Vehicle Headlamp Levelling

Measurement data of several vehicles
equipped with automatic levelling
Influence of the components of the system

Headlamp levelling – review of proposals

Headlamp levelling data vs requirements

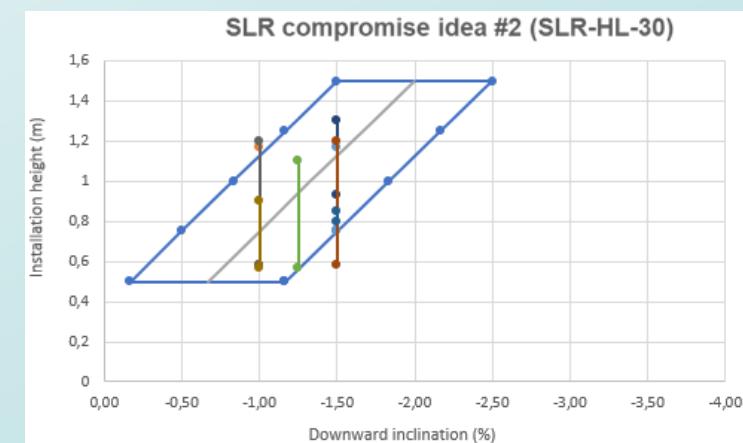
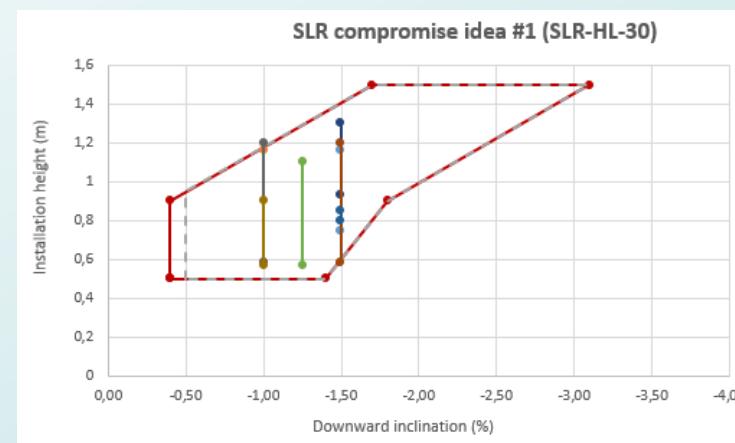
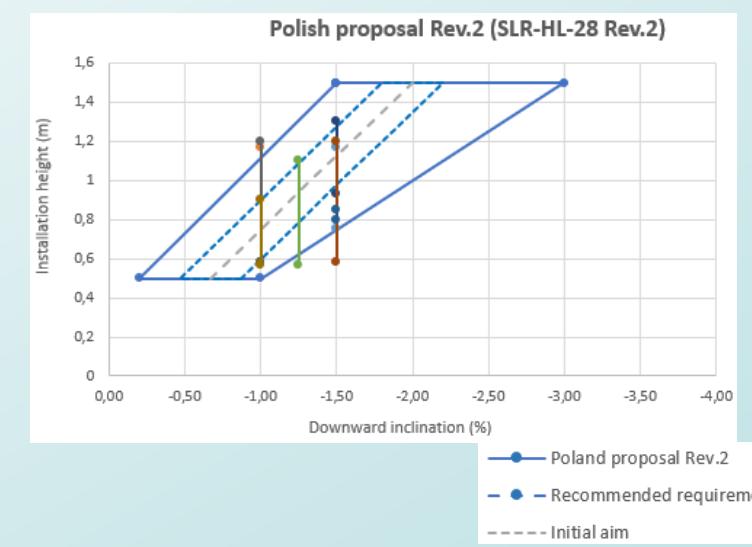
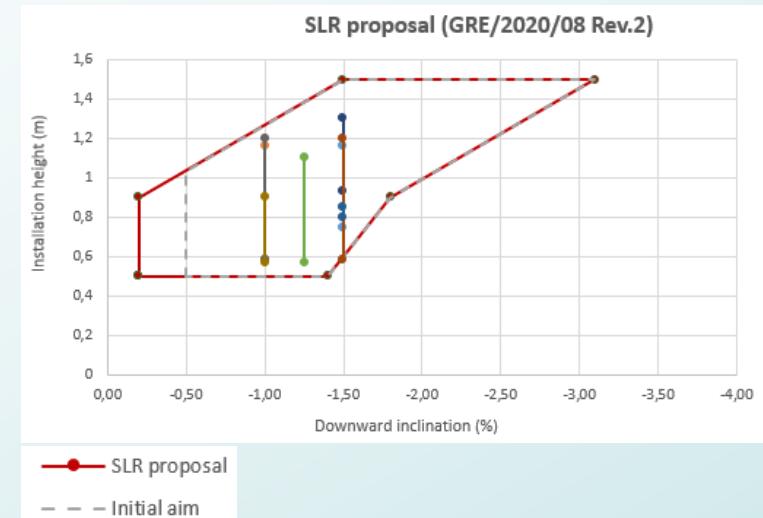
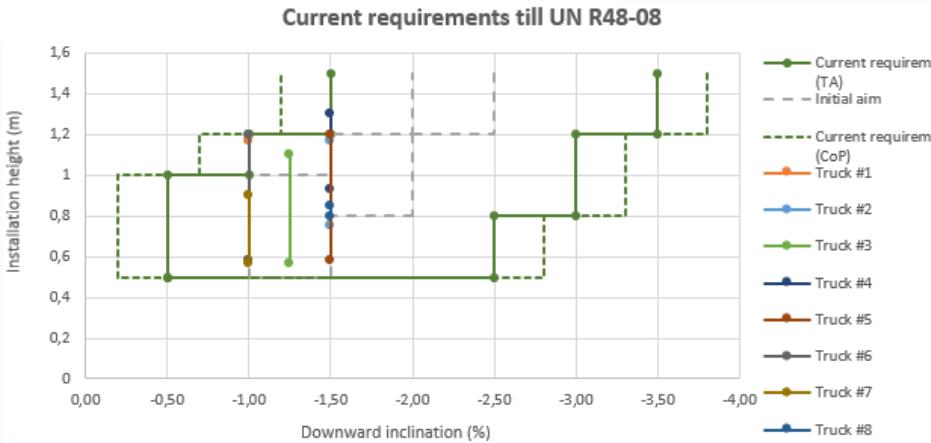
- The requirements of the SLR proposal (GRE/2020/08 Rev2) can be met with existing automatic levelling devices, except for some truck categories.
- Variation in model derivatives and production tolerances result in changes of height that would require different initial aim markings.
- An automatic levelling system is designed to work for all variants of a vehicle model from basic to fully equipped, to remain within the aiming limits for all loading states.
- The data representative of trucks shows the large diversity of installation heights on a vehicle range, for a same headlamp model.

- Vertical inclination for all loading conditions:
 - With only a few exceptions, most automatic levelling systems installed on current passenger vehicles can meet the SLR proposal.
 - The same number of exceptions (vehicle data outside the boundary) apply equally to the SLR compromise idea #1.
 - However, for trucks, only the requirements of original SLR proposal and SLR compromise idea #1 could be met.
 - For all vehicle types, the range of the vertical inclination is too strict in SLR compromise idea #2 and the original PL proposal.
